# UNC RECOVERY SYSTEMS

January 28, 1980  
CEB 80 - 25

The purpose of this letter is to submit additional information regarding the operation of the facility approved by Amendment No. 4 to License SNM-777. That amendment authorized treatment of lagoon and process wastes by evaporation of the liquid and drying of the solids, in preparation for shipment to an authorized burial site. We are currently preparing that facility.

LICENSE; SNM-777, DOCKET 70-820	Page 1 of 8
SECTION 900 RECOVERY OPERATIONS	Approved
PART 925.17 RECLAMATION AND TREATMENT OF IMPOUNDED RESIDUES	Issued January 28, 1980
	Supersedes March 26, 1979

PROJECT: MI-099-1

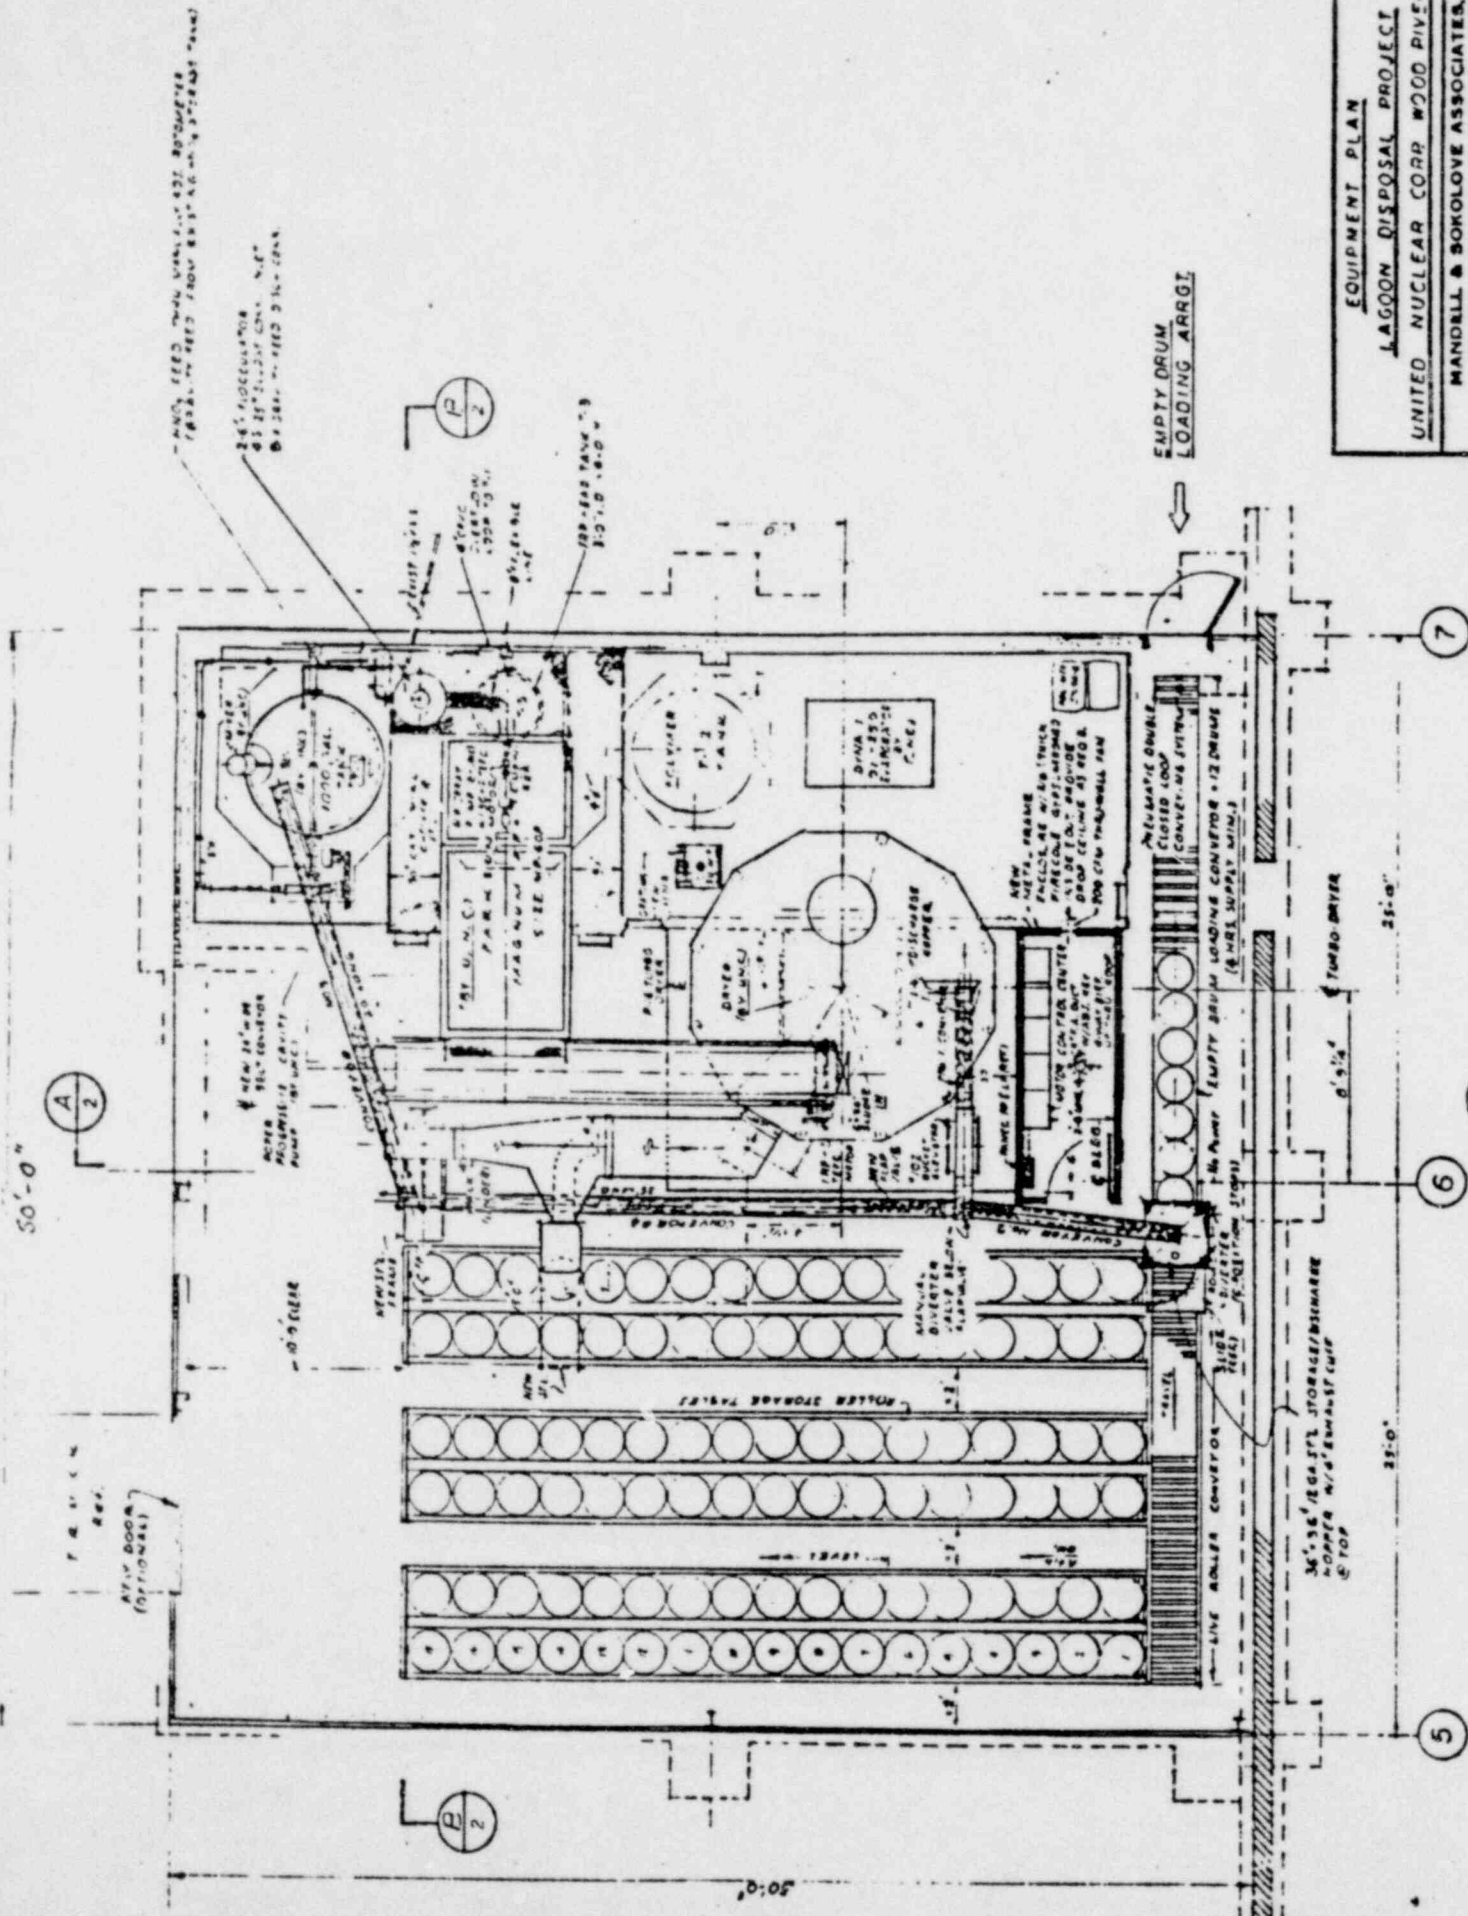
A separate bay, approximately 15 feet high and 50 x 50 in area extends from the main process building to the north. The original north building wall of cement blocks remains as a permanent physical divider. The plan view, elevation, location and floor equipment layout are shown in drawings MI-007-2, MI-097-3, MI-097-4, and MI-097-5. An optional layout for use in liquids evaporation and solids drying is shown in drawing MI-099-1.

In combination with or in lieu of the reclamation process described above, the lagoon and process waste materials may be treated by direct evaporation of liquids, drying of solids, and containerization. In this case, the treatment of the waste material in the lagoons and the waste being generated by the plant operation will be accomplished by elimination of moisture through the use of heat and the subsequent transfer of the dry residue to 55 gallon drums. Disposal of this material will be by burial at an authorized burial site or alternate acceptable means. The equipment and layout for this treatment is shown in drawing MI-099-1.
